# URBAN DESIGN COMMITTEE

## URBAN DESIGN COMMITTEE STAFF REPORT

APPLICATION NUMBER    Urban Design Record #UDR25041

ADDRESS/LOCATION        Public Building Commission Parking Garage Expansion  
(425 S 10<sup>th</sup> St)

Option 1 shows colored perforated metal panels.

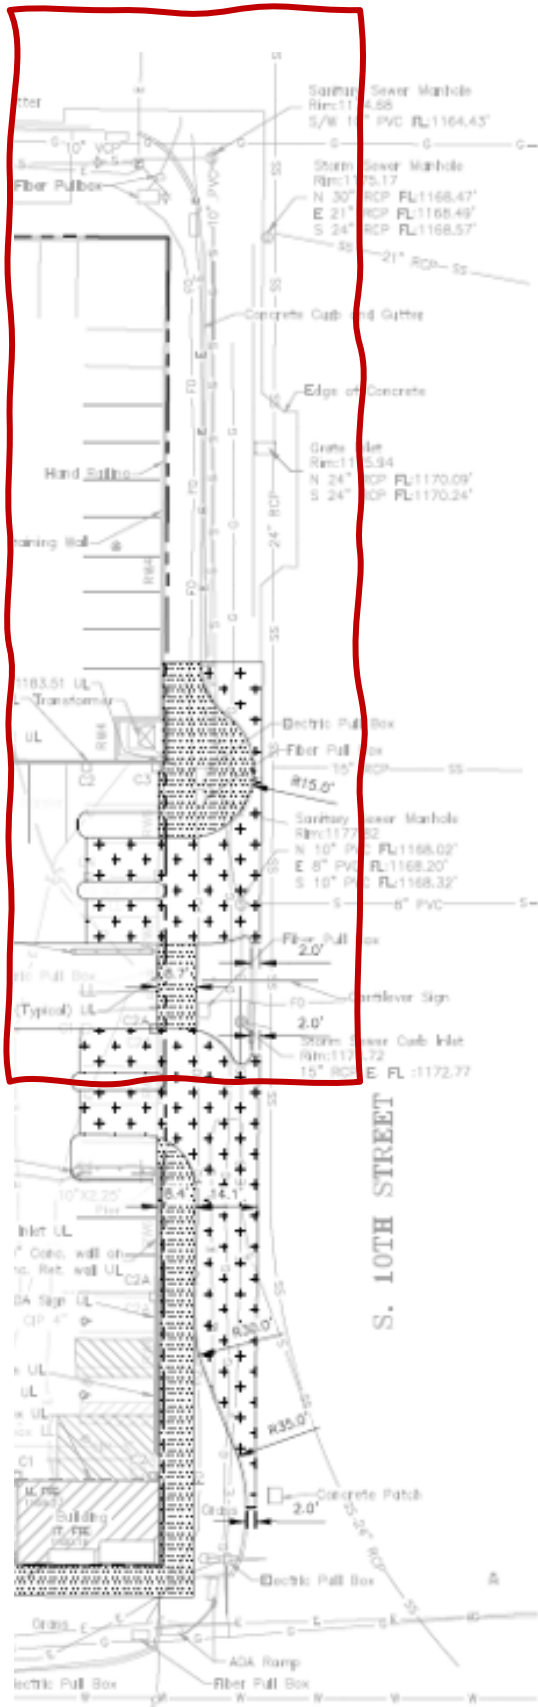
While the project incorporates precast concrete fins on the south, west, and north facades to reflect the architectural language of the existing PBC Campus, staff have identified opportunities for enhancement, particularly along the K Street and 9th Street elevations. These elevations are highly visible and serve as key gateways into Downtown. In the current proposal, their similarity to the adjacent structures does not create a distinctive or inviting entry experience.

To strengthen the identity and visual appeal of these façades, staff recommends the incorporation of additional design elements, such as perforated or colored metal panels, murals, colored fins, or other creative treatments that contribute to a more dynamic and engaging street presence.

Additionally, the current design proposal includes a mural at the corner of the east façade, and staff notes that this location is less visible in the broader urban context. We recommend relocating or replicating the mural concept on the more prominent K Street or 9th Street elevations, where it would have a greater visual impact and contribute more

meaningfully to the character of Downtown. Future development on the north sides of the block will also hide this mural.

Attached below is a street cross-section and a perspective of the proposed design, followed by two examples of treatments that could elevate the façade of the building.

Proposed plan

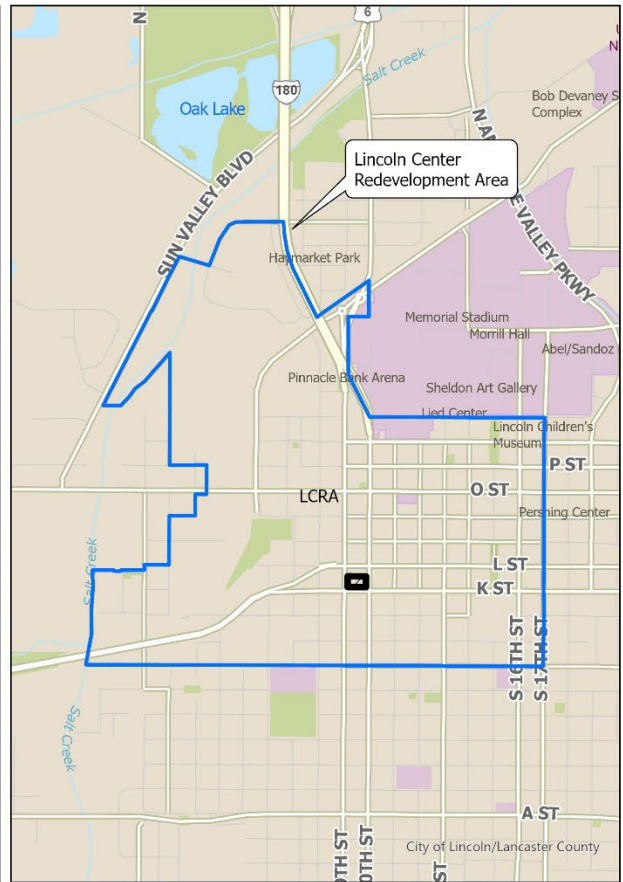
It is also noted that the proposed treatment of 10th Street does not show the proposed plan for 10<sup>th</sup> St outlined in the Downtown Corridors Master Plan. Staff recommends revising the site plan and accompanying drawings to maintain consistency and reflect the proposed streetscape improvements for this corridor.
